Review of Plans: Fisher Site Plan, 7 Berachah Avenue, South Nyack, NY
Section 66.61 Block 1 Lot 19-2 R-12HC zone

Subject: **Fisher Site Plan**
7 Berachah Avenue, South Nyack
Section 66.61, Block 1, Lot 19.2, R-12HC zoning district

Final Subdivision Plan as prepared by Lawler, Matusky & Skelly Engineers, LLP, signed by South Nyack Planning Board Chair, 6-22-2005 Site Plan as prepared by Sparaco & Youngblood PLLC, last revised 2/26/2024 and Architectural Plans as prepared by Kier B. Levesque, RA, last revised 2/23/2024.

PB #23-04: Fisher Site Plan
Critical Environmental Area-South Nyack
Preliminary Site Plan Approval Subject to Conditions
Neg. Dec.

CARPORT PLANS &
ELEVATION

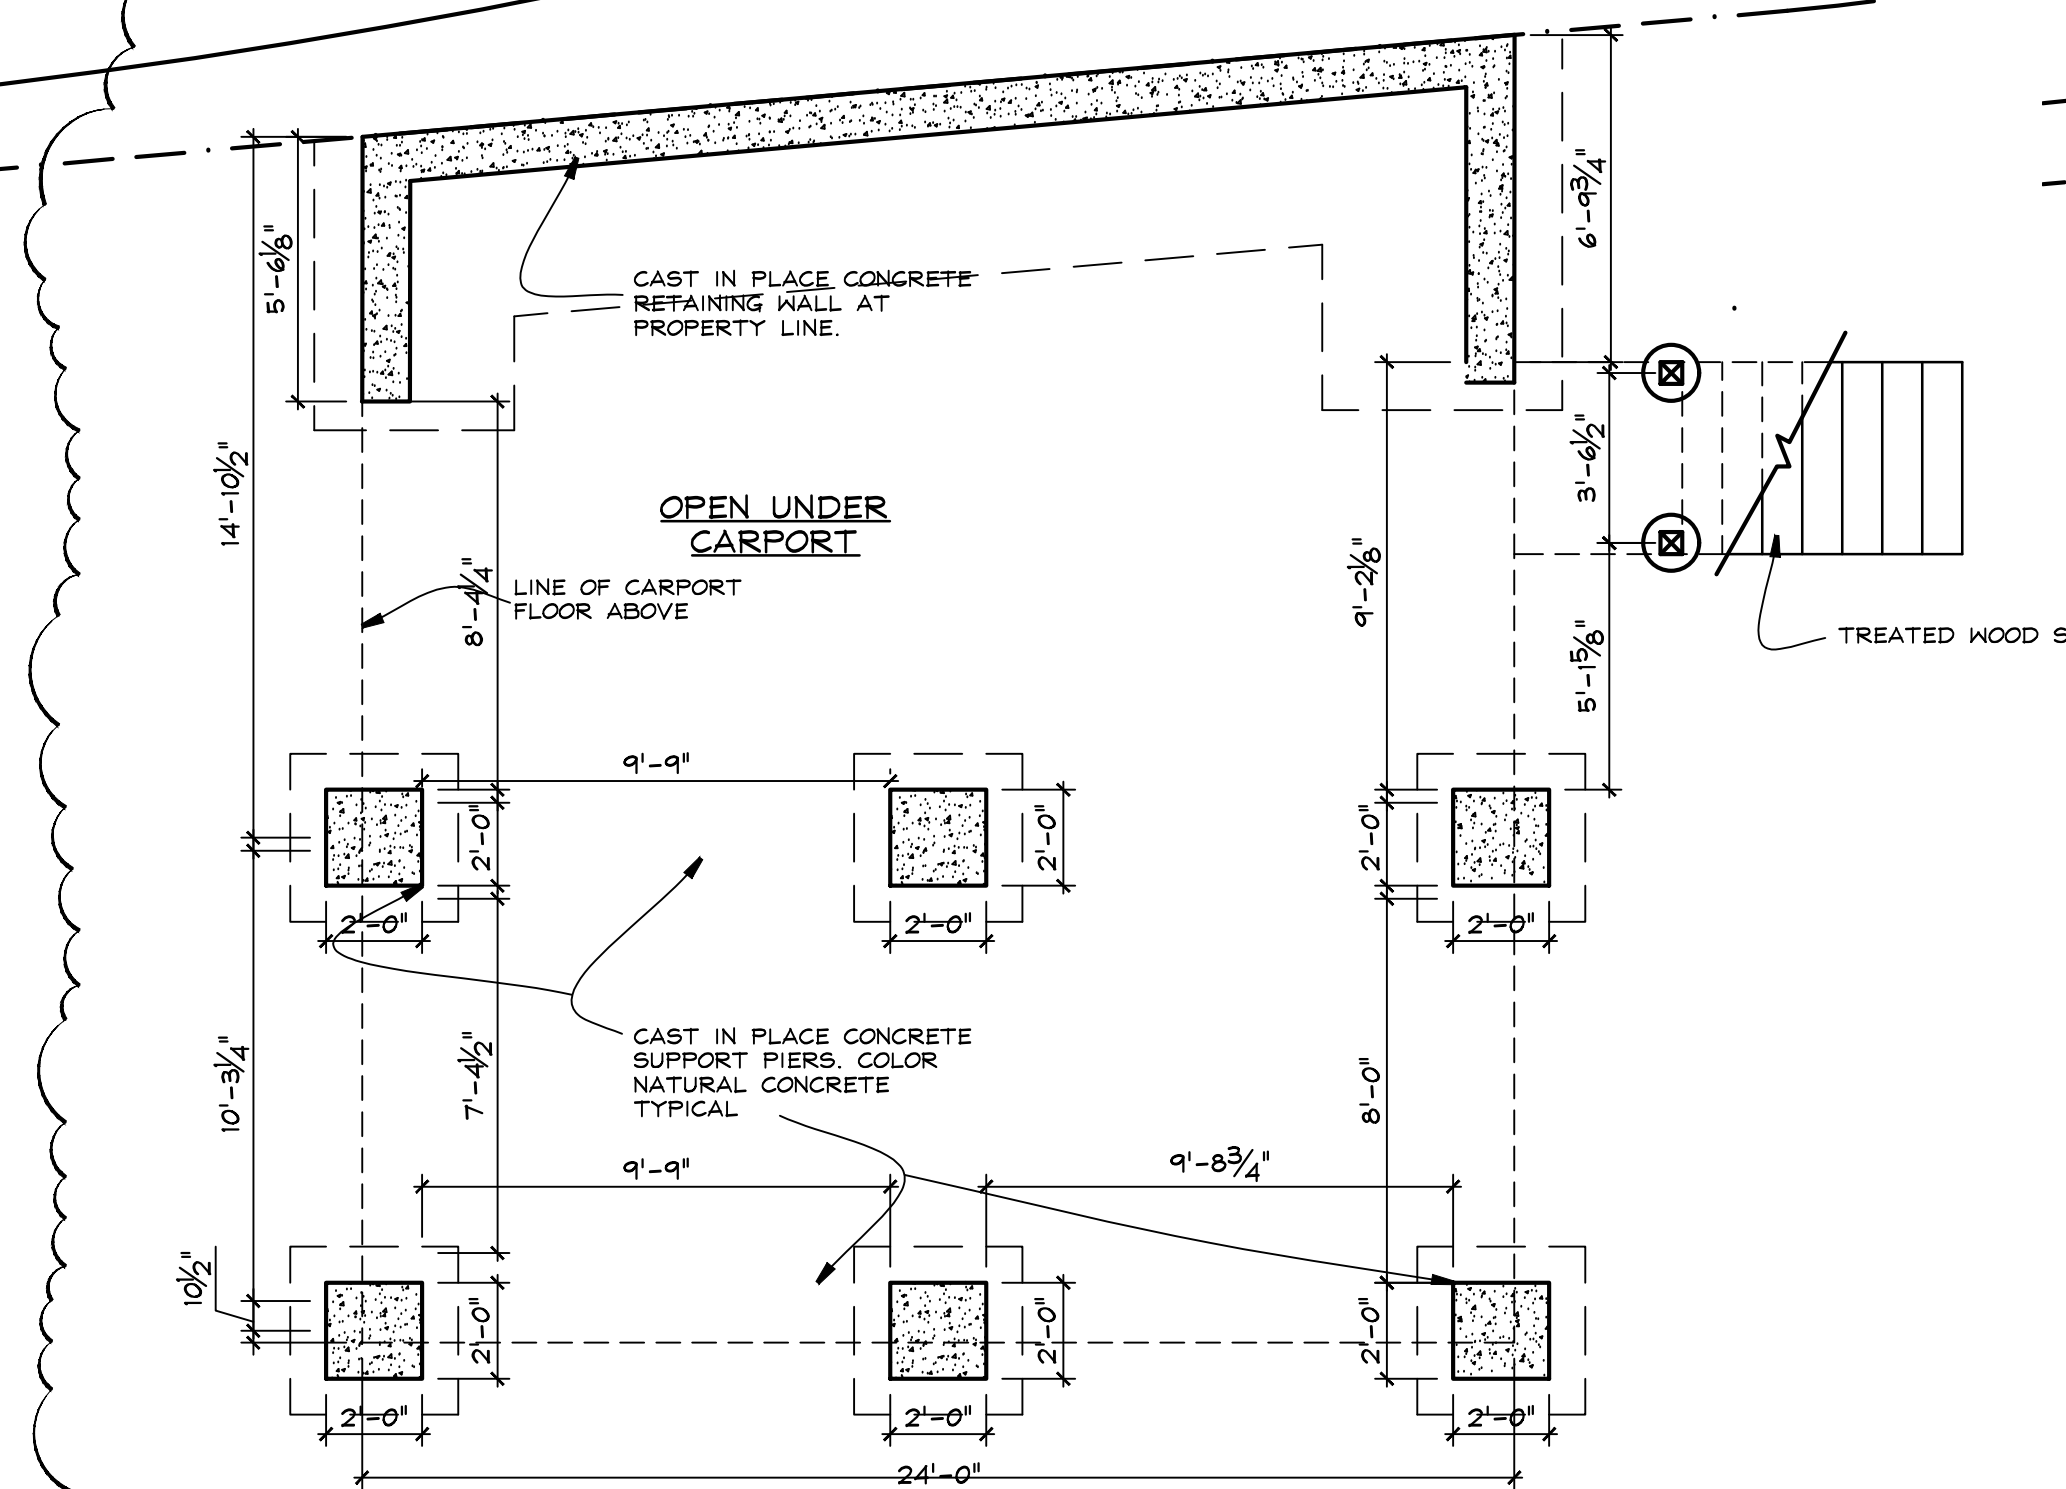
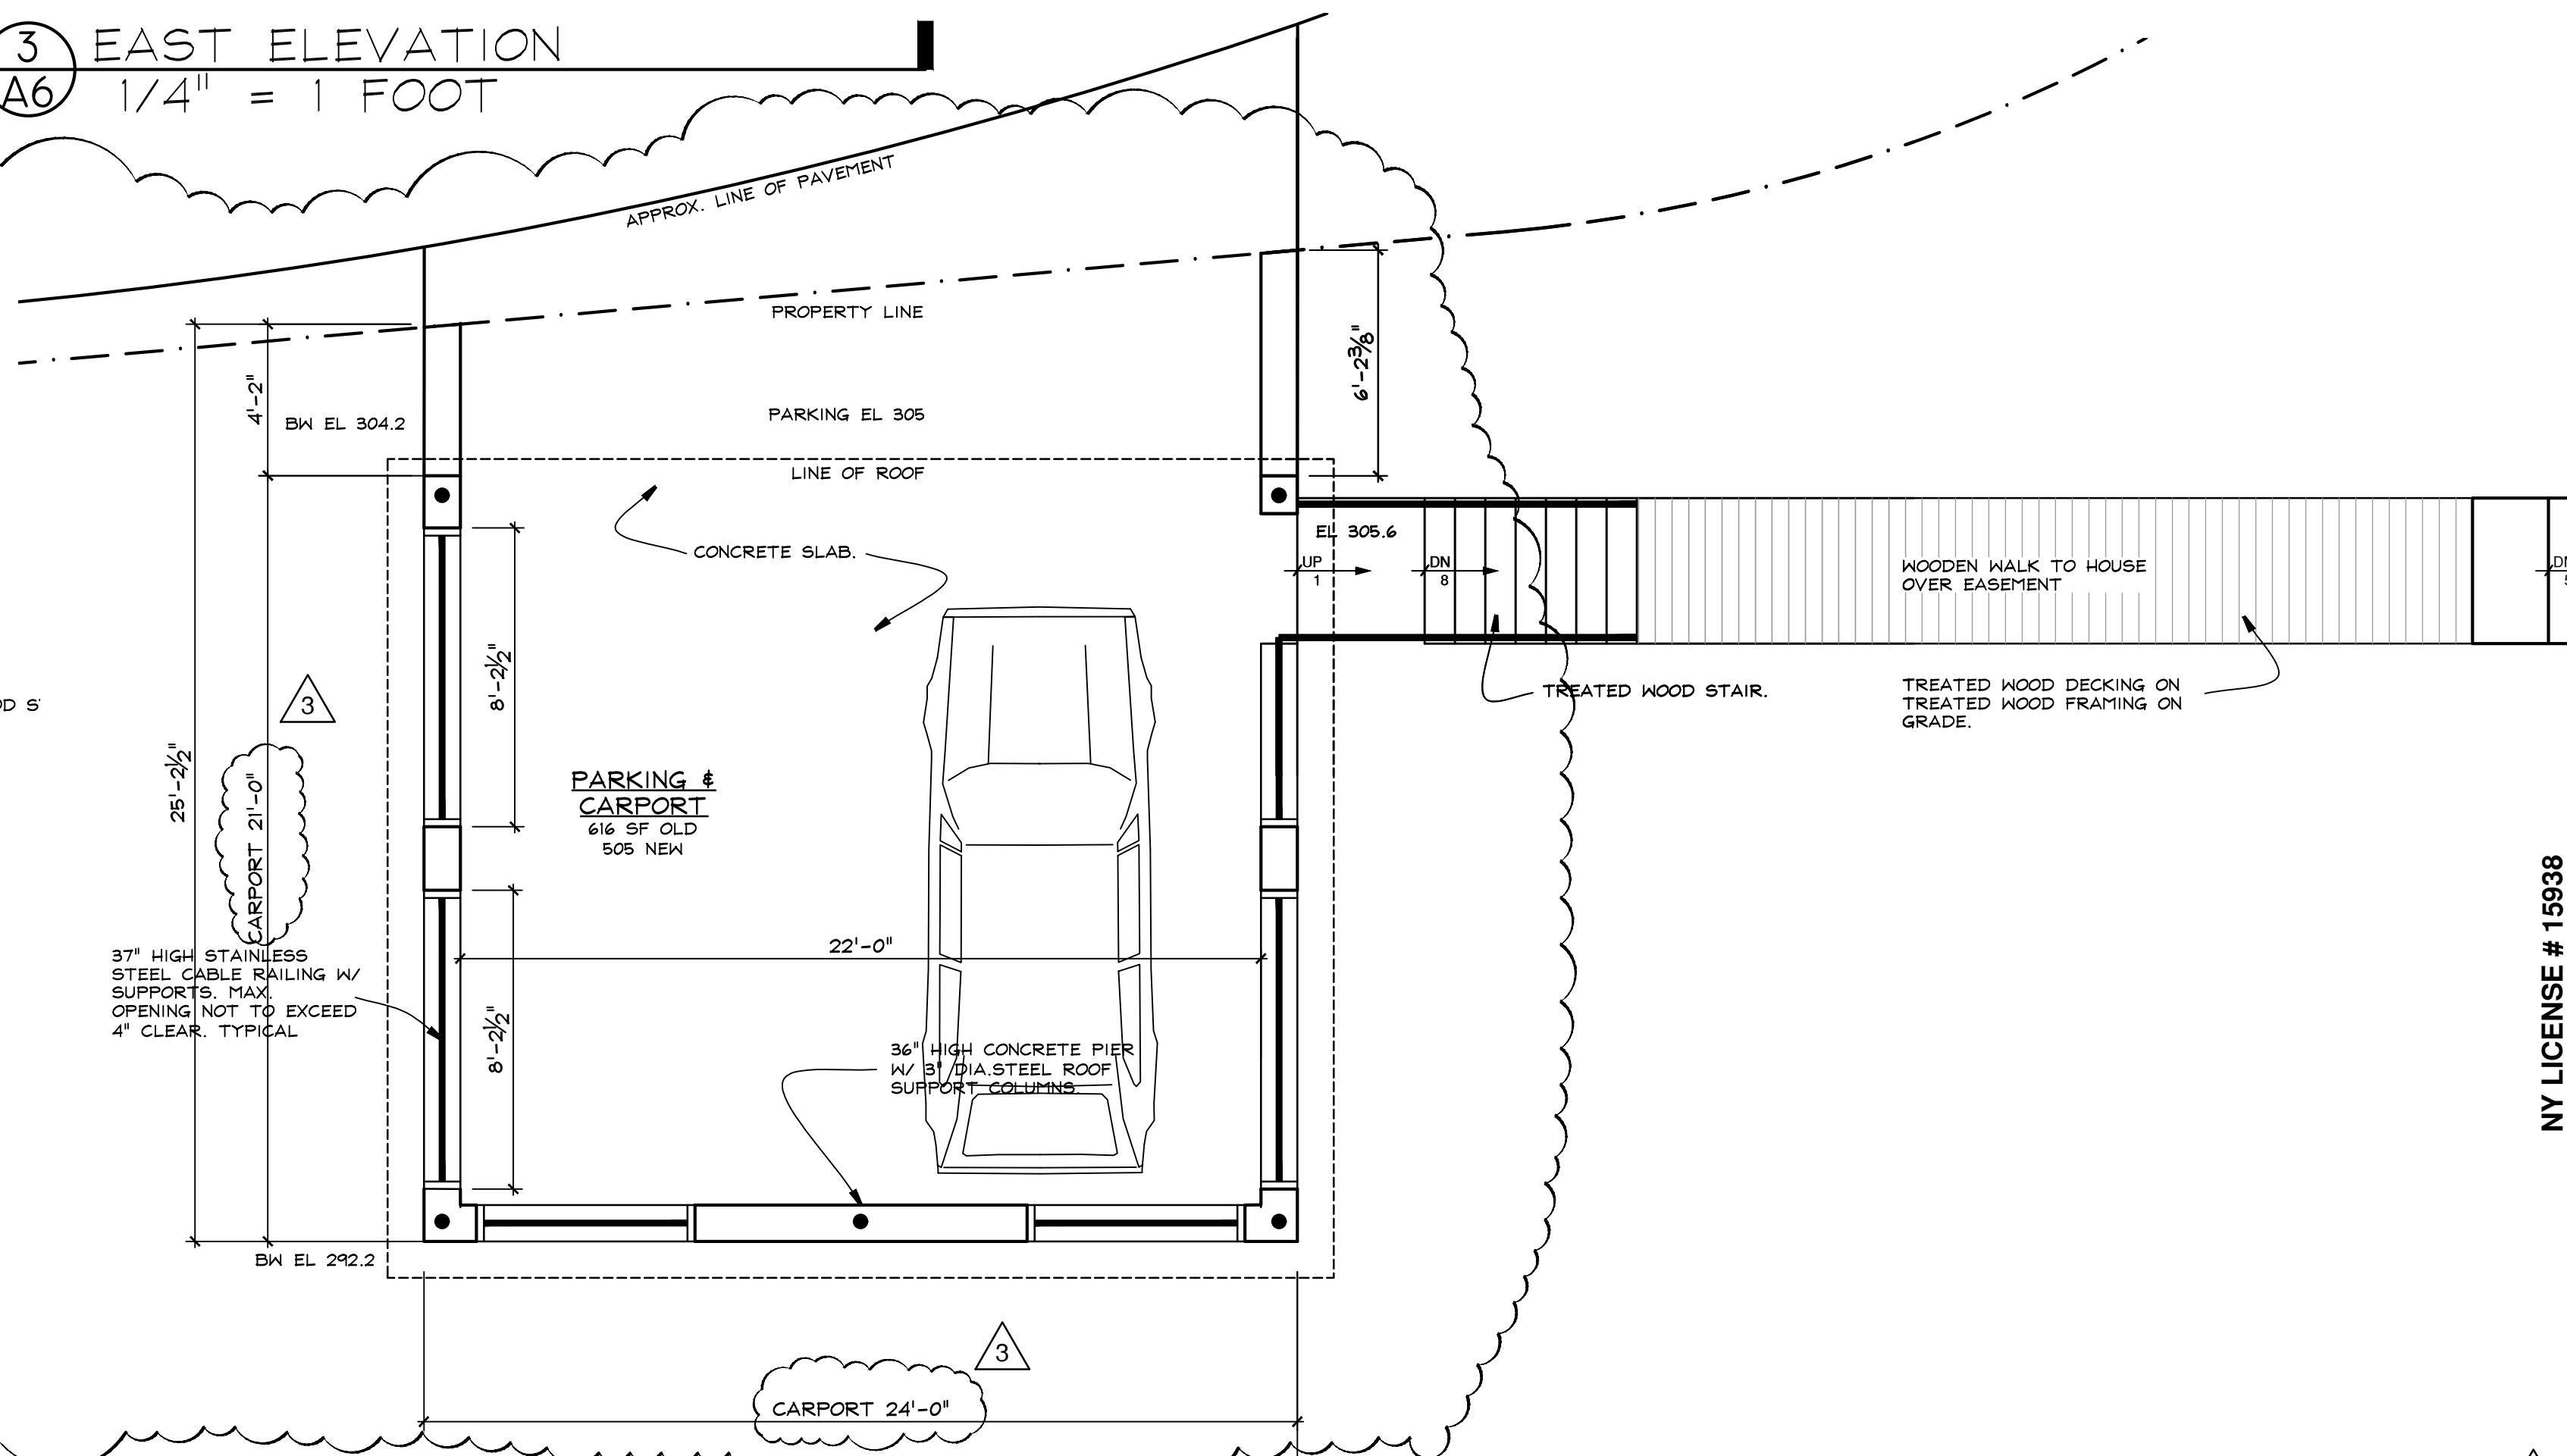
- 2) Per RG-8 Zoning district chart on page 7 of the subdivision plan the following variances are required;
 - a) front yard setback to carport is 4 feet, with 55 feet required to accessory structures.

- b) proposed carport is 505 square feet which results in a lot coverage of 10.6% with 7% required for accessory structures.
 - c) Maximum lot coverage permitted is 45% with 55% proposed.

- 4) Per Chapter 43, Article XVIII (18), section 18.35, “*Maximum building height applicability. In considering maximum height per Hamlet of South Nyack General Use, Bulk and Parking Regulations, per Figure 1, when considering a front yard setback variance for any structure, allowable roof height to the topmost extremity shall not extend above a line drawn from 5 1/2 feet above the nearest point on the front lot line to a point 30 feet above the required front yard setback. An exception to this limit may be granted only if there is no other feasible alternative and if the balancing of benefits to the applicant if granted, versus benefits to the community if not granted, weigh strongly in favor of the applicant.*” Variance required as a portion of the carport roof is outside of the envelope, see sketch.
- 5) College Avenue is a private road, a 280-A Variance is required.
